## **CABINET MEMBER FOR ENVIRONMENT – 11 JANUARY 2018**

### **A4144 WOODSTOCK ROAD OXFORD – PROPOSED RAISED SIDE ROAD ENTRY TREATMENTS**

**Report by Director for Infrastructure Delivery, Communities**

**Drawing title:**  
**LOCATION PLAN  
 SOUTH PARADE TO  
 MORETON ROAD  
 RAISED SIDE JUNCTIONS**

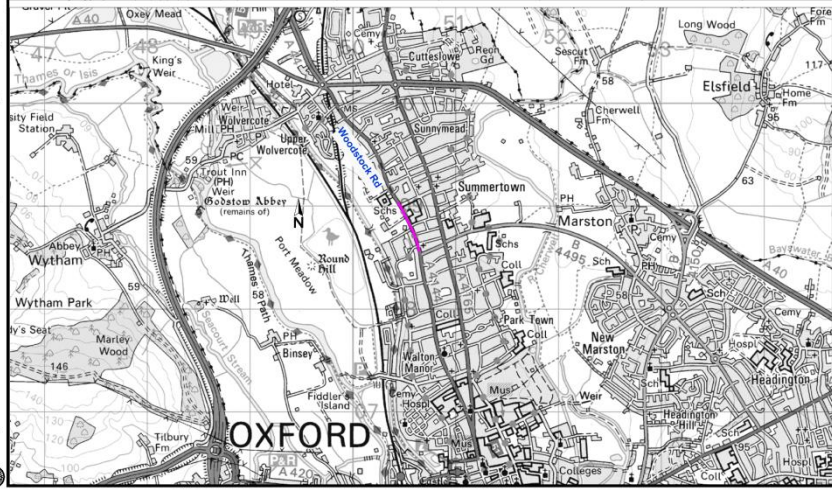
4. Nine responses were received. These are summarised at Annex 2 with copies of full responses available for inspection by County Councillors.
5. Thames Valley Police expressed no objection. Cyclox, the Oxford cycling group, supported the proposals but qualified this by expressing the view that the layout of the South Parade junction should be amended to reduce the width of the entry both for the benefit of pedestrians crossing here and to help ensure that vehicles turning left onto the Woodstock Road positioned themselves at a right angle to the main road to facilitate their view of cyclists in the bus lane; they also requested that the height of the treatment is increased to 100mm (from the 75mm currently proposed) and for details of the proposed road markings to be provided. Additionally they raised wider issues beyond the scope of the current proposals in relation to the safety and amenity of cyclists on the Woodstock Road and adjacent side roads.

RESPONDENT	SUMMARISED COMMENTS
(1) Traffic Management Officer, (Thames Valley Polcie)	<b>No objection.</b>
(2) Cyclox	<b>Support</b> - We support the concept of doing a raised side entry treatment, but with reservations, including the need to tighten the layout the of the South Parade junction, and to increase the height of the treatments to 100mm (rather than the 75mm as proposed), and subject to the detail of the road markings. A considerable number of other improvements are desirable for the safety and amenity of cyclists on the A4144 Woodstock Road and adjacent side roads (see accompanying email).

(4) Online response, (unknown)	<b>Object</b> - While I see the point of placing a hump in the road to slow down cars turning off faster roads into residential side roads, I totally fail to see how a hump at the junction of South Parade with Woodstock Road would improve road safety.  Traffic is already obliged to stop at the end of South Parade, which is a one-way street, before turning to join the Woodstock Road.

8. The response of Thames Valley Police expressing no objection is noted.
9. Cyclox's response and that of the member of the public expressing very similar views are similarly noted. It is proposed to amend the southern kerbline of South Parade slightly, albeit not to the extent that appears to be requested in these responses, with the two lane approach to the junction being maintained, noting that this junction does have a good safety record. The only reported accident here in the latest five years involved a vehicle turning into South Parade failing to comply with the no entry sign and therefore not considered relevant to the issues being raised in these responses. The specification of the raised treatment in respect of its height (75mm) is as widely used in other similar treatments, with the proposed road markings also following established practice. The County Council shares the aspirations expressed by Cyclox to significantly improve the safety and amenity of cyclists, including on the A4144 Woodstock Road and adjacent streets, but it is considered that the suggestions made in this respect fall outside the scope of this maintenance scheme, excepting the comment on the camber of the road, which will be reviewed.
